Process Sheet

Customer	: CU-DAR001 Dart Helicopters Services			Drawing Name	HARNESS ASSEMBLY	
Job Number	: 32337			Part Number	: D412702111B	
Estimate Number	: 12859			Drawing Number	: ICA D412-702 P.79	
P.O. Number	: N/A			Project Number	: N/A	
This Issue	: 5/14/2007 S.O. No. : N/A			Drawing Revision	: D	
Prsht Rev.	: NC			Material	: N/A	
First Issue	: N/A			Due Date	: 5/15/2007	
Previous Run	: N/A			Qty:	6	Um: Each
Written By	: <i>APR 14, 2007</i>			Comment	: est rev A 07-05-11 new issue EC	
Checked & Approved By						
Comment

Drawing Name: HARNESS ASSEMBLY

Part Number: D412702111B

DETAIL 'L' D412-702-111A/-111B/-113A/-113B HARNESS ASSEMBLIES INCONTROLLED COPY
(BELTS AND D3569-1/-2/-3 DECALS NOT SHOWN)

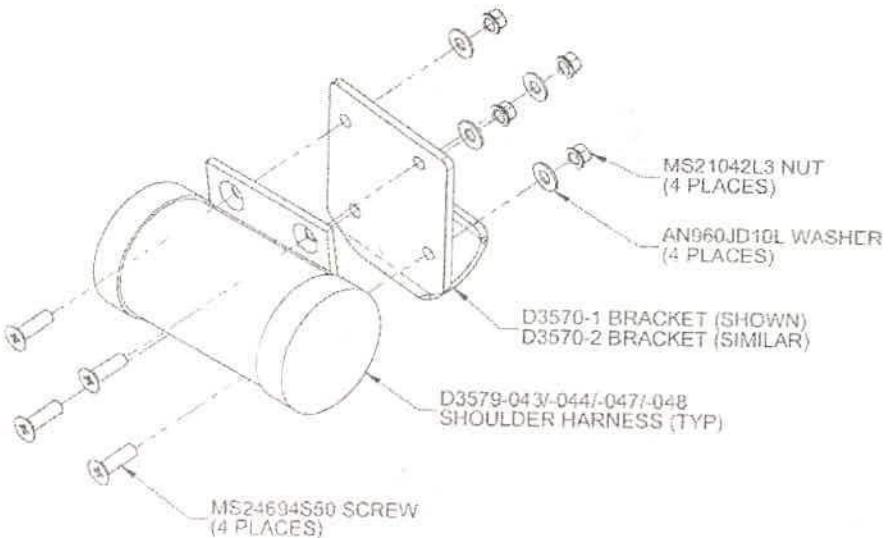
NCR:		WORK ORDER NON-CONFORMANCE (NCR)						
DATE	STEP	Description of NC Section A	Corrective Action Section B			Verification Section C	Approval Chief Eng	Approval QC Inspector
			Initial Chief Eng	Action Description Chief Eng	Sign & Date			
07/05/16	3	label D 3569-3 do not stick	UB 07-05-16	Use contact Ament mro2565 SEE ATTACHED EMAIL FROM SUFFORTH	ml 07/05/16	/0705-16	45 07-05-16	/0705-16

Marianne – we'd like to have a decal adhered with crazy glue (edges only) to one side of the plastic buckle casing of SL 20 and SL36.L9/R9. Since the casing is not a structural component of the buckle, is this acceptable?

Per our conversation this email is to approve the change of the temporary adhesive from "Krazy Glue" to LePaige Contact Cement LCP506.

Schroth Safety Products will allow the addition of the decal using "Krazy Glue" for the one shipment of restraints with SL 20 plastic buckles shipping today only. Schroth will not take responsibility for any failures of the housing due to the addition of the Krazy Glue to the plastic housing.

Please note that under no circumstances does this email approve Krazy Glue to be used on and SL 36 buckles.
